CITY OF ALBUQUERQUE

RE: Townhomes for Greg Lobbereg
Grading and Drainage Plan
Engineer's Stamp Date 12-30-2016 (File: H22D026)

Based upon the information provided in your submittal received 12-30-2016, the above referenced Grading and Drainage Plan cannot be approved for building permit and SO-19 permit until the following comments are addressed:

GRADING AND DRAINAGE PLAN

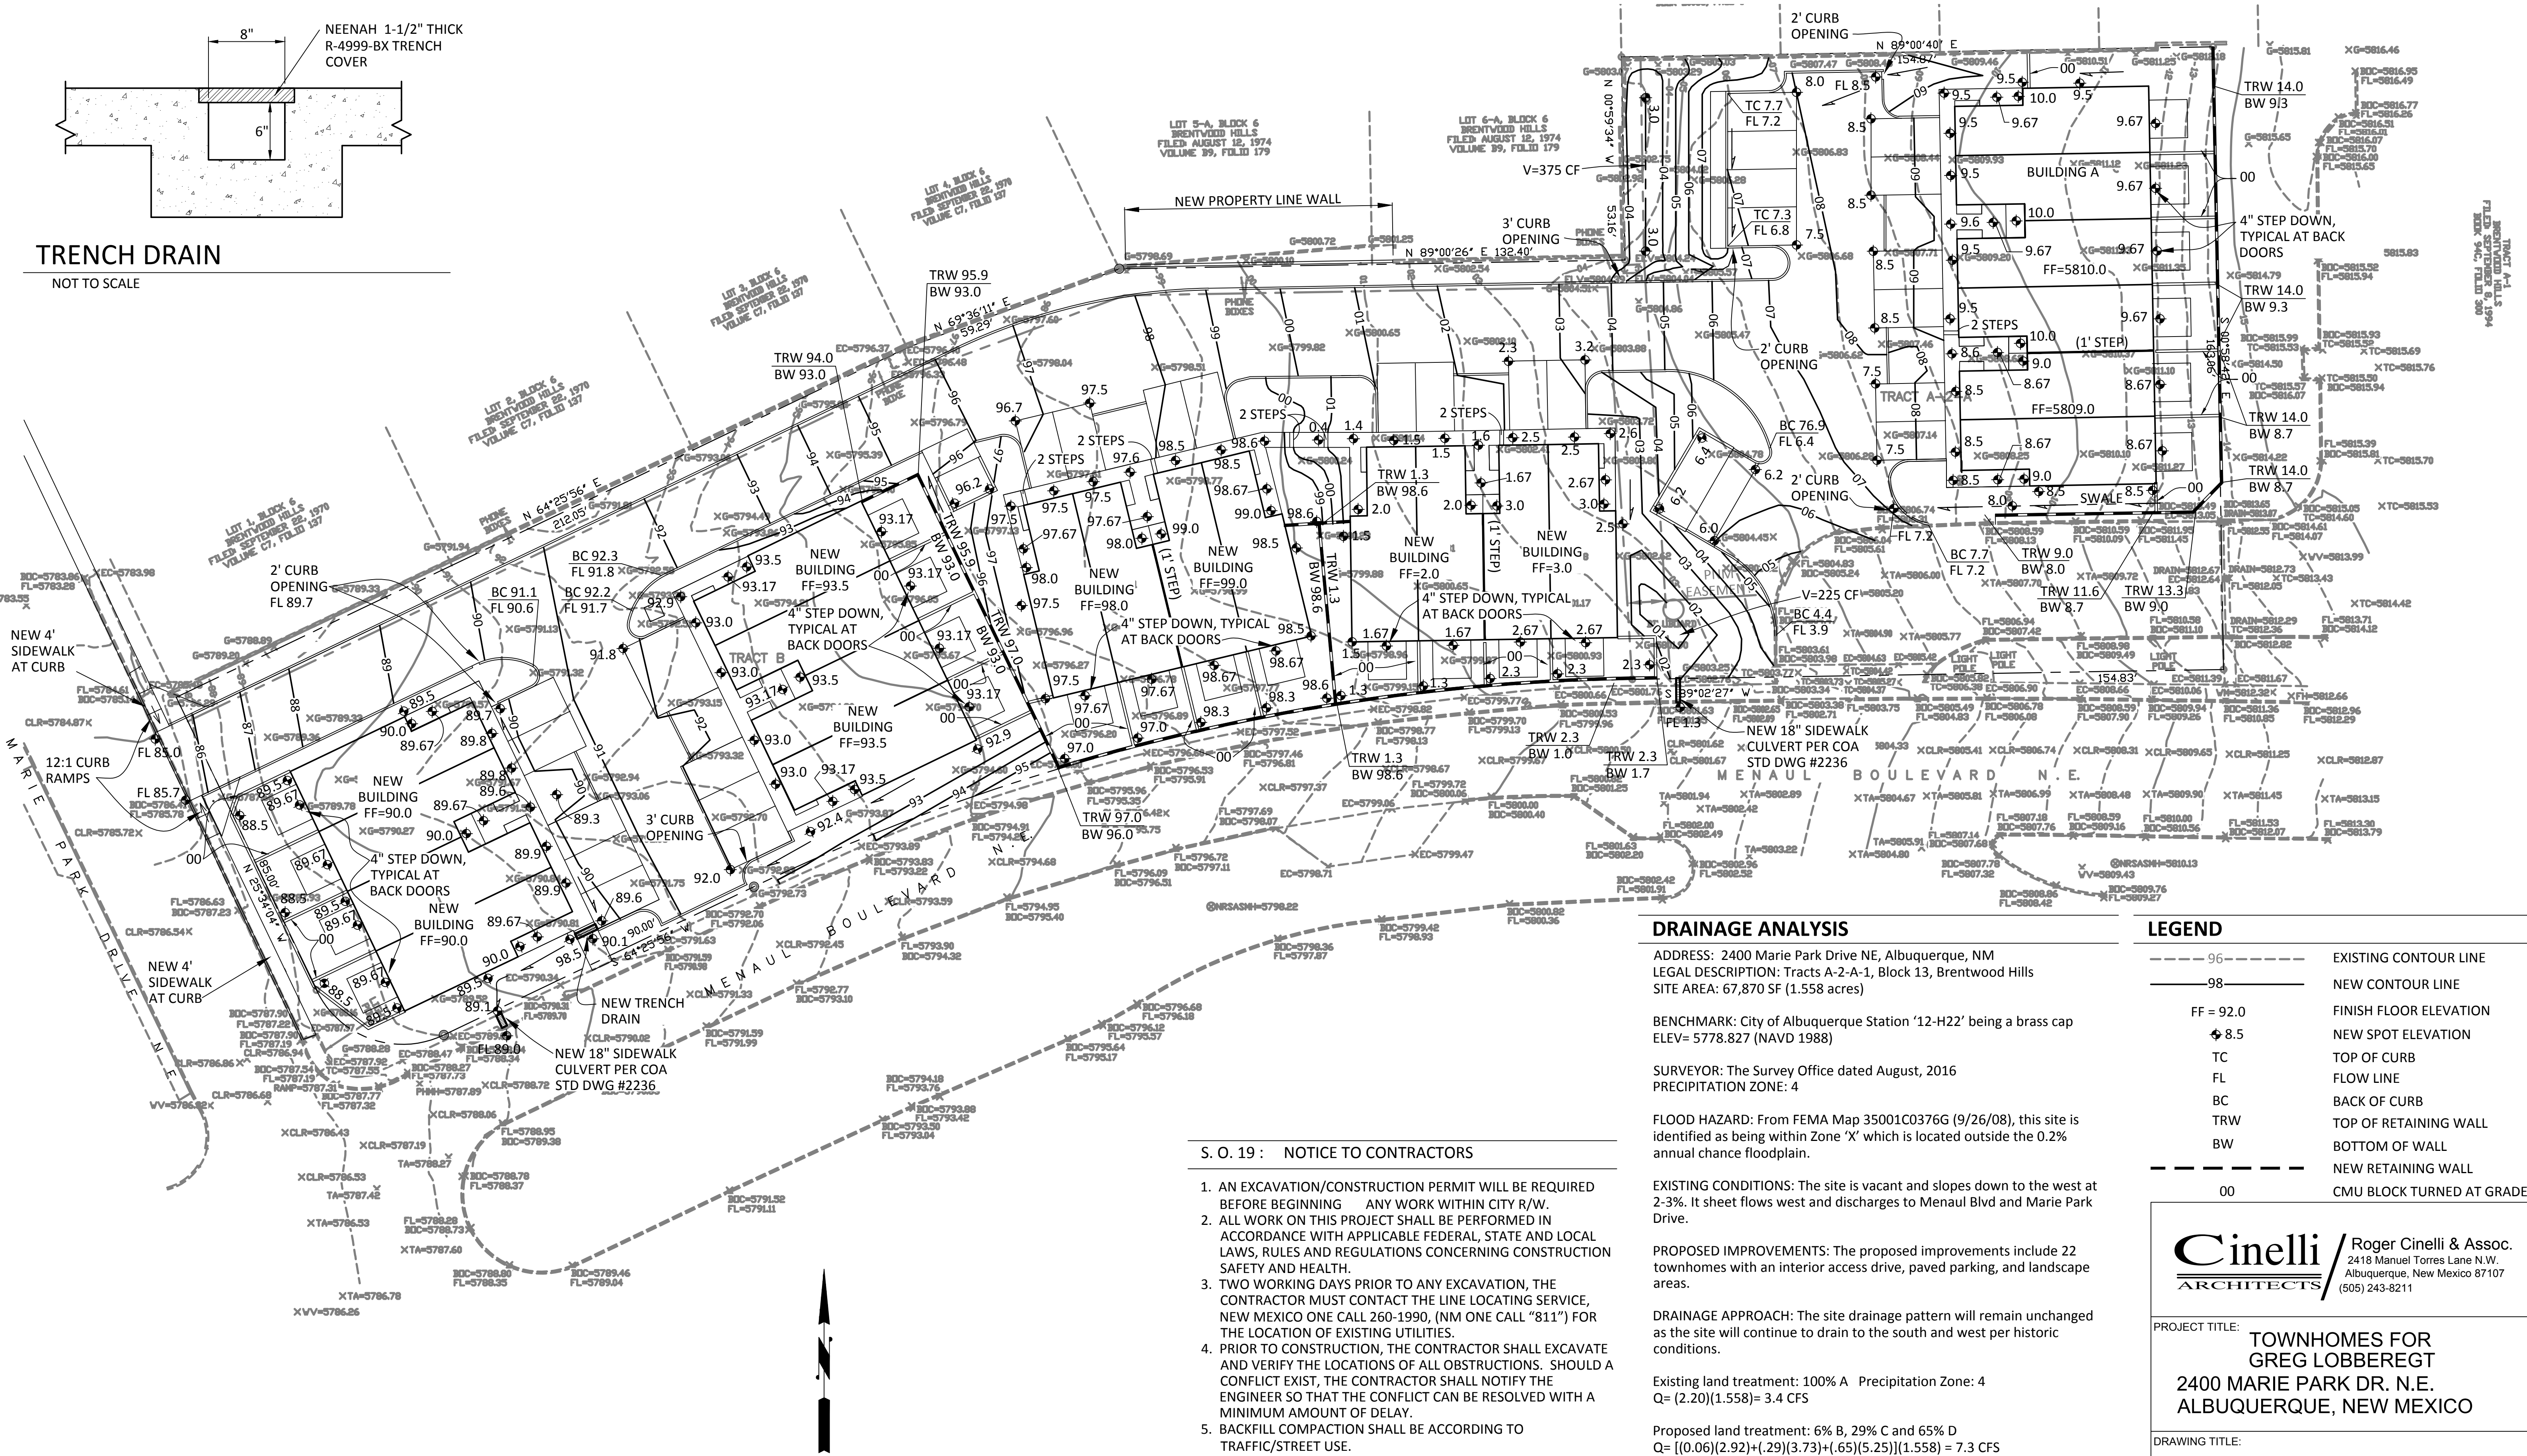
1. Provide a vicinity map.
2. Provide a narrative for offsite flow.
3. Provide back yard details and typical lot layout.
4. Provide first flush calculations for back yard separately from rest of site.
First flush volume for back yard can only be for previous surface in back yard.
5. Provide a curb cut north of the dumpster enclosure for the south east pond.
6. Provide a curb opening at regular intervals along the north side of the site.
7. Depress all landscaping area at the north side of the site.
8. ESC plan and ESC permit is required. (coordinate with a stormwater quality engineer).
9. For town house that backup to the street consider drain them to the street.
10. Extended sidewalk culvert plate 1 foot behind the sidewalk.
